UNITED STATES PATENT AND TRADEMARK OFFICE

APPLICATION NO.	FILING DATE	FIRST NAMED INVENTOR	ATTORNEY DOCKET NO.	CONFIRMATION NO.
09/872,319	06/01/2001	Lennart Axelsson	LCB 363	4554

Office Action Summary

DETAILED ACTION

Fig. 1

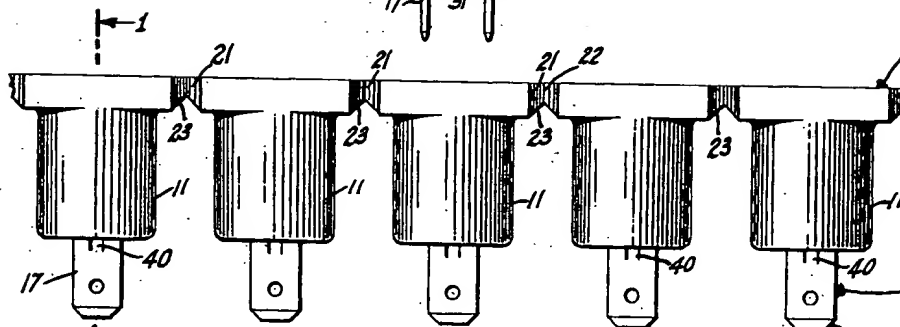
5. Claims 1-6 are rejected under 35 U.S.C. 102(b) as being anticipated by Clarkson et al. (U.S. Patent No. 3,082,397). With regard to Claim 1, Clarkson et al. discloses a terminal (Fig. 1) disposed on a carrier strip (Fig. 2), the terminal (Fig. 1) comprising: a contact portion (tip portion of 13 and 15); and a generally round barrel portion (11) attached to the carrier strip (Fig. 2), the barrel portion (11) having a generally squared shoulder (Attachment 1) where the barrel portion (11) meets the carrier strip (Fig. 2), the squared shoulder (Attachment 1) facilitating cutting the terminal (Fig. 1) completely from the carrier strip (Fig. 2). See Figs. 1-6 and Attachment 1.

With regard to Claim 3, Clarkson et al. discloses the terminal (Fig. 1) further comprising an intermediate portion (Attachment 1) disposed between the contact portion (tip portion of 13 and 15) and the barrel portion (11). See Figs. 1-6 and Attachment 1.

Squared
Shoulder

Intermediate
portion

Contact
portion
